S E R V I C E N O T E

16600A Logic Analysis System Mainframe

Mainframe System RAM and Video RAM is Upgradable

DATE: December 1998

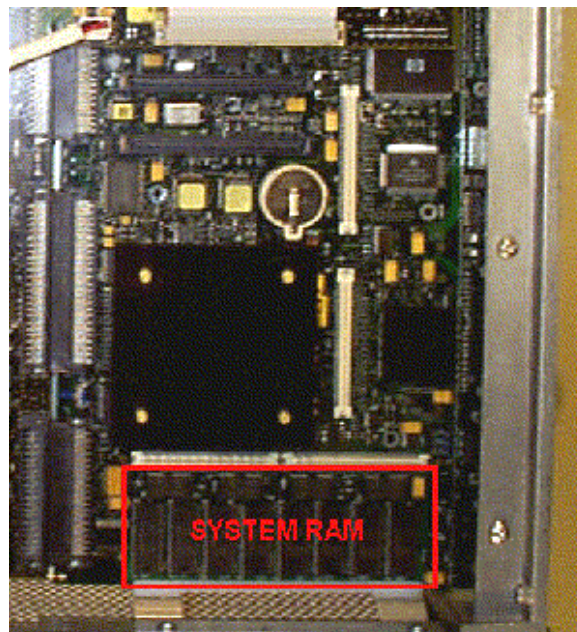
1. The service center orders the 128 MB System RAM Daughter Card and the Video RAM Module from GSL.
2. Using the procedures in the service manual, remove the top cover from the 16700A mainframe.
3. Remove the 32MB daughter card from the daughter card connector pair J4/J10 on the CPU board.

4. Install the 128MB memory daughter card into the daughter card connector pair J4/J10 on the CPU board, Ensure the daughter card also properly engages the nylon standoffs.

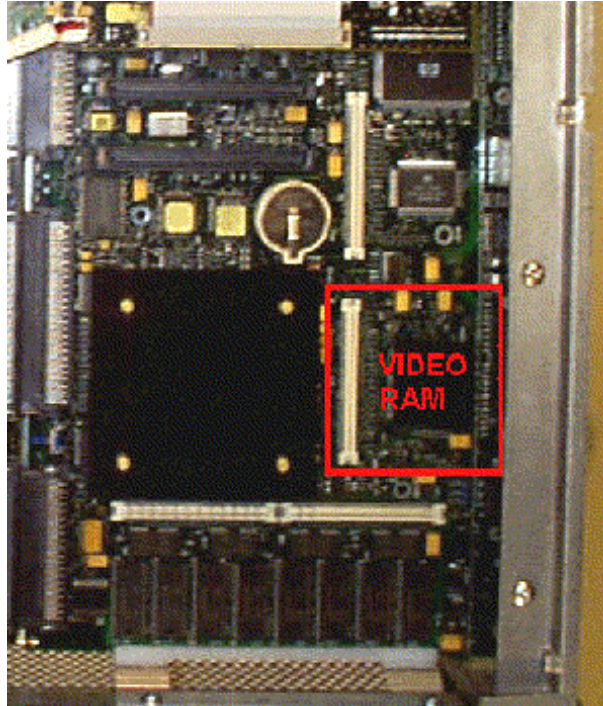
1 Locate the Video RAM Module connector J11 on the CPU board.

2. Install the Video RAM Module into the Video RAM Module connector J11 on the CPU board. Ensure the daughter card also properly engages the nylon standoffs.
